RE: Presbyterian San Pedro FSED 6400 Paseo Del Norte NE Grading and Drainage Plan Engineer's Stamp Date: 06/26/18 Hydrology File: D18D056

Based upon the information provided in your submittal received 06/27/2018, the Grading and Drainage Plan **is not** approved for Building Permit and Grading Permit. The following comments need to be addressed for approval of the above referenced project:

GRADING & DRAINAGE

A6 CONCRETE RUNDOWN

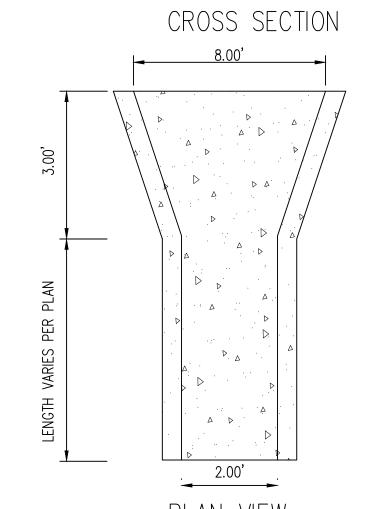
- 3. Please provide the benchmark information for the survey contour information provided.
- 4. Please provide the weir calculations for the curb cuts and concrete rundown.
